# Defining the training patterns

NVIDIA

Comments 414 and 415

# Revised default seeds (for both synchronous and free-running)

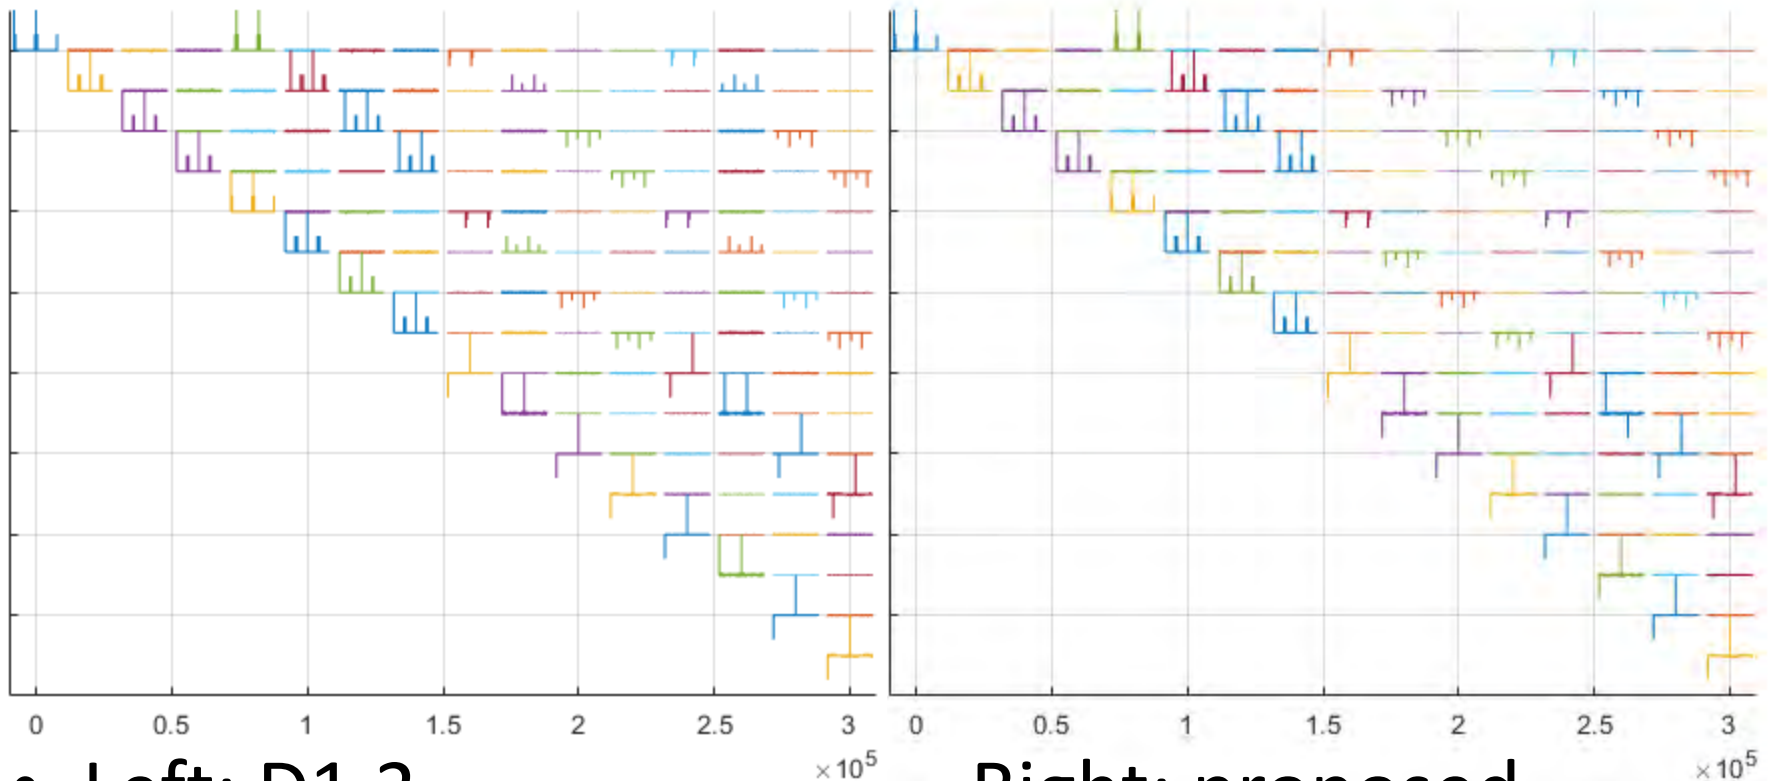
- Baseline wander statistics of the possible PRBS13Q, 4 polynomials, both precoded and not, any seed
- Four unbalanced patterns should be avoided
  - The standard should warn against creating these
- The two on the left are precoded,  $i$  is 1 or 5, with the default seed
  - The two on the right are precoded, "Default identifier" (polynomial ID) 3, and a non-default seed
- Some patterns are 8191 UI long, some precoded patterns are 16382 UI long

- Baseline wander statistics of the proposed set of PRBS13Q, 4 polynomials (8  $i$ ), both precoded and not, revised default seeds
- The unbalanced patterns are avoided
  - for the proposed default seeds
- The 4 non-precoded patterns are 8191 UI long, the 4 precoded patterns are all 16382 UI long
  - Nice minor benefit

$i$	Default identifier (ID of polynomial)	Default seed_ $i$		Comments
		D1.2	Proposed	
0	0	0000010101011	0000010101011	
1	1	0011101000001	0111010000011	Rotated 1 bit
2	2	1001000101100	1001000101100	
3	3	0100010000010	0100010000010	
4	0	1111110100110	1111110100110	
5	1	1100011101110	1000111011100	Rotated 1 bit
6	2	0000001101000	0000001101000	
7	3	0011000100111	0011000100111

To avoid ambiguity, it may be desirable to add another UI to the "Initial output, PAM4 with precoding" column

# Tabulated correlations

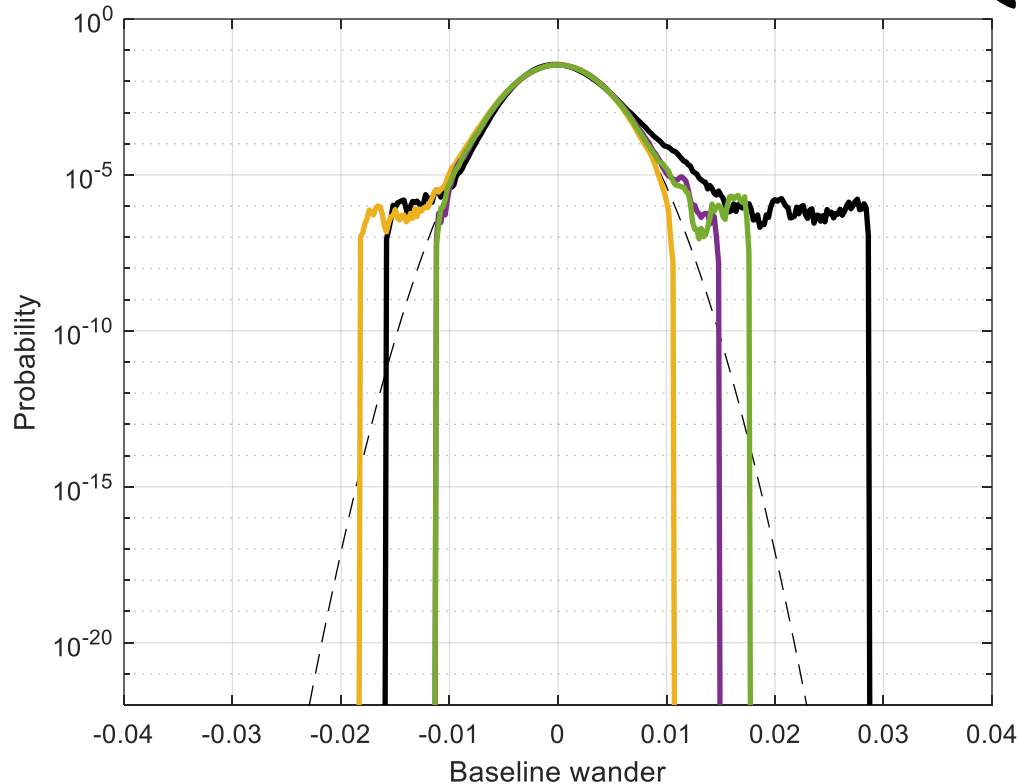
- Left: D1.2
- The sign of some correlation peaks is changed
- Otherwise, no significant difference. See table on next slide, and backup slides
